City of Portland  
**Bureau of Development Services**  
Land Use Services Division

**NOTICE OF A TYPE II DECISION ON A PROPOSAL IN YOUR NEIGHBORHOOD**

**CASE FILE NUMBER: LU 08-109513 DZM - DESIGN REVIEW WITH A MODIFICATION FOR ALTERATIONS TO EXISTING RESIDENCE**

**Site Address:** 2204 SE 48TH AVENUE

CASE NO. 08-109513 024  
 EXHIBIT C-1

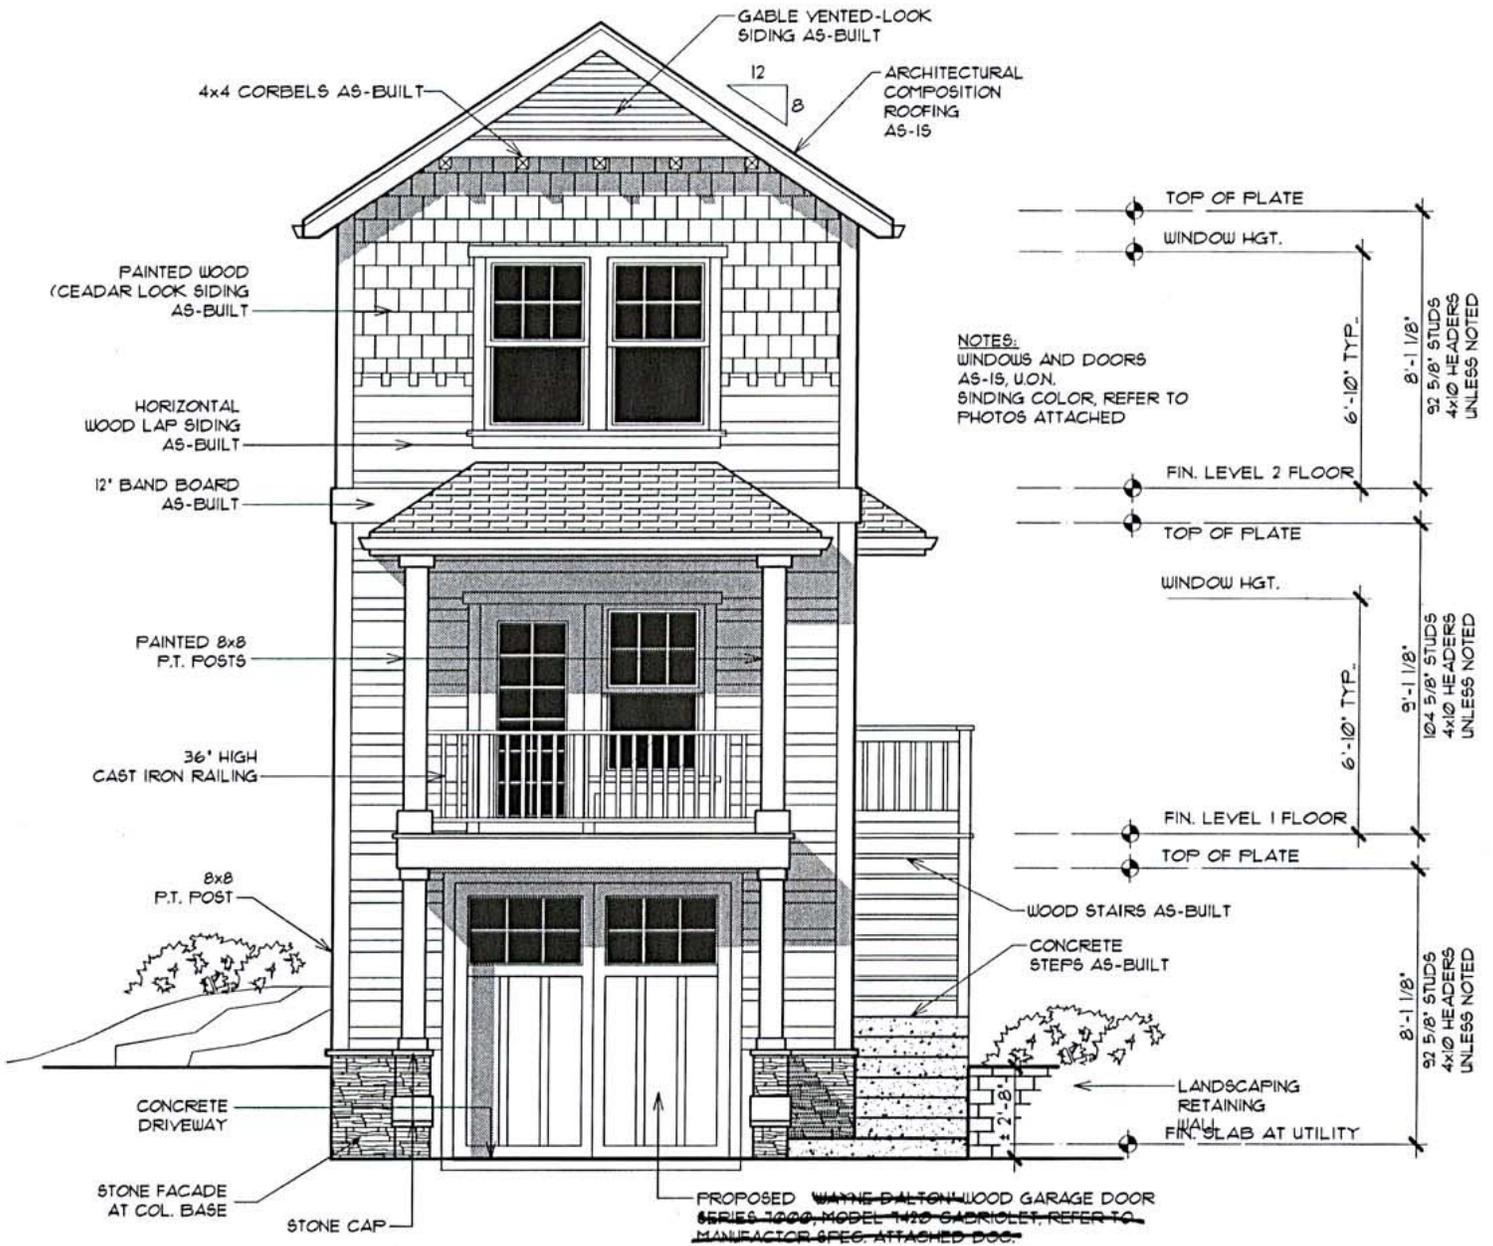
1. Site Development is unable to support the change to replace the approved stair landing at the rear door with a 15’ X 7’ deck unless a plumbing code appeal is granted to allow the deck to be located within the drywell setback.

**Modification #1:** Building Coverage (Section 33.110.225) – The maximum building coverage allowed for this 1,250 SF site is 40% of its area thus 500 SF. The addition of the 15'x7' at the rear of the residence increases the building coverage to 667 SF (53%).

**Findings:** The original design review approval included a modification to exceed the maximum building coverage by 4.9%. The majority of this additional coverage resulted from architectural building features including a covered front balcony, an entry canopy over the main entrance and a landing and stair off the rear door. During construction, however, the rear landing and stair was converted to a 15'x7' deck, which provides a usable outdoor area at the 2<sup>nd</sup> level of the house. This additional 105 SF is included in the building coverage for the site since its height is over 6'-0". Similar to the other covered porches and balconies on the building, this deck is an architectural feature of the building that does not affect the footprint of the residence as it is not floor area. The open work design of the deck with no roof, an openwork railing and only posts underneath, result in a light, transparent element that does not add to the bulk of the structure. The deck is in line with the side building walls meeting the 5'-0" setback from the rear and side property lines. Its transparency and integration with the house fits within in the neighborhood and does not overwhelm the adjacent houses thus meeting the intent of the standard. Furthermore, the material and style of the deck match the covered balcony and side entry, providing a cohesive design and interest to the rear façade of the building better meeting Design Guidelines D6 (Architectural Integrity) and D8 (Interest, Quality, and Composition). *This modification therefore warrants approval.*

2. Replace approved shed roof on front balcony and gable roof on the side entry cover to hipped roofs;
3. Replace approved stair landing at rear door with 15'x7' deck;

1. Building Coverage (Section 33.110.225) - A modification to increase the maximum building coverage to 53%.

- A. As part of the building permit application submittal, each of the 4 required site plans and any additional drawings must reflect the information and design approved by this land use review as indicated in Exhibits C-1 through C-5. The sheets on which this information appears must be labeled, "Proposal and design as approved in Case File # LU 08-109510 DZM. No field changes allowed."
- B. Applicant must obtain approval for encroachment on the drywell protection zone through the Plumbing Appeal process prior to final sign-off of the building permit.
